**AGENDA  
for the  
REGULAR MEETING  
of the  
CITY of KINGSPORT  
GATEWAY REVIEW COMMISSION**

**SUBJECT: Reedy Creek Winery: Final Plan and Certificate of Appropriateness**

**PROJECT #: 11-105-00011**

**REEDY CREEK CELLARS**  
 KINGSPORT TENNESSEE  
 SITE AND FLOOR PLAN

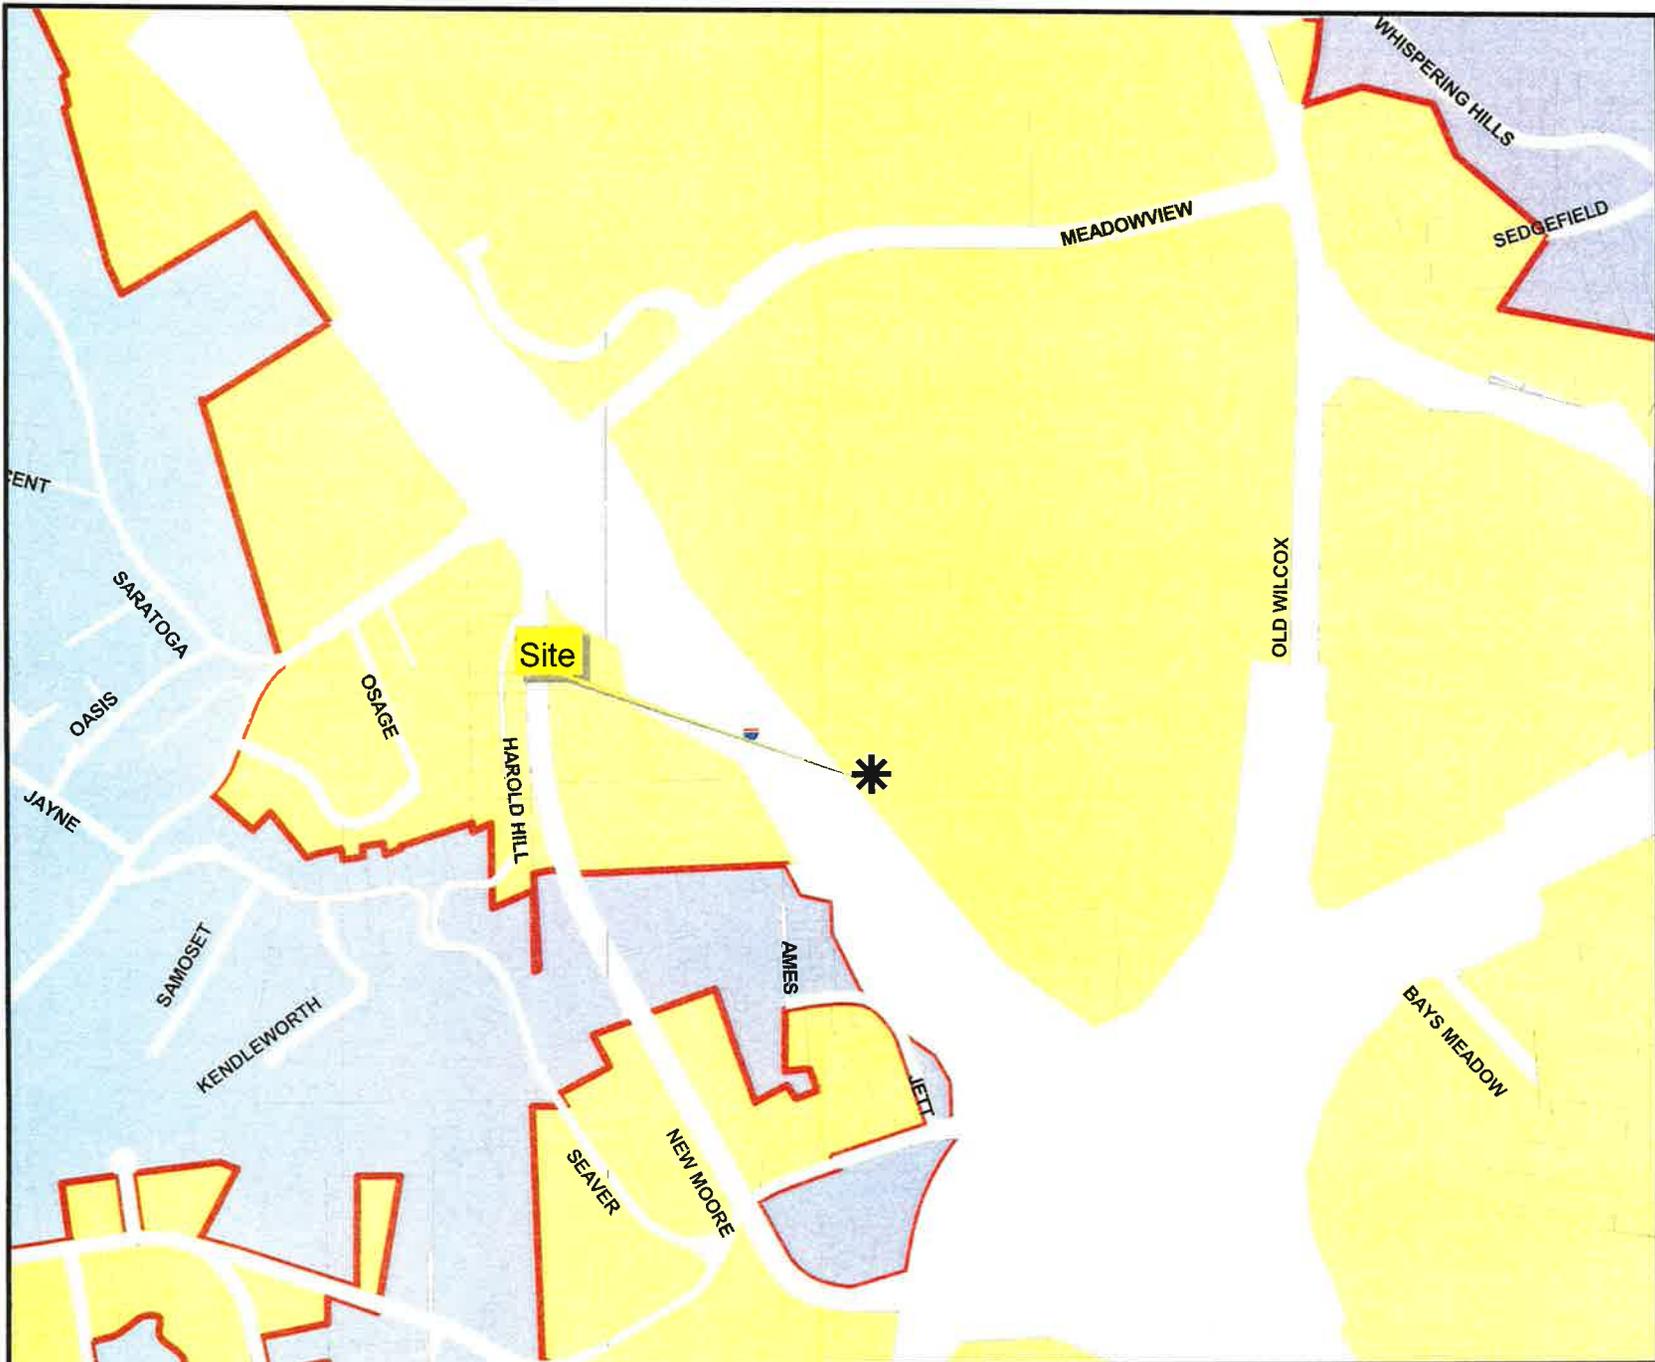
The existing facility is a split face painted block walls to ceiling finish height and includes metal vertical panels up to the roof line. In order to make this more in concert with Gateway regulations, the proposal is install a pergola type planted trellis along the front of the existing building with grape vines growing throughout the length of the trellis providing a covering to the entire length of the front facade. This will help subordinate the metal paneling above the split faced block wall and bring the space adjacent to the building down to a human scale. At the far end is the addition which will be the sales office with a stacked stone column and standing seam metal roof over the front entry. To the right of the entry is the rounded turret feature with stone walls and casement type openings for windows. The remaining front façade will be of stone and have a planting area in front of the exterior wall.

Minimal landscaping is required for the addition. The Plan indicates grapevines planted along the trellis to grow up the trellis and in front of the new sales office there will be three new 2" caliper dogwood trees to repeat the existing one on the far right of the addition which was an island. There is a heat pump as you face the building on the right corner. Staff recommends screening this unit with either a type of material to match the material used in the trellis or using shrubs to screen this mechanical equipment.

**Recommendation:** Grant approval issuing the Final Certificate of Appropriateness for Reedy Creek Winery contingent upon the changes staff recommended being implemented.
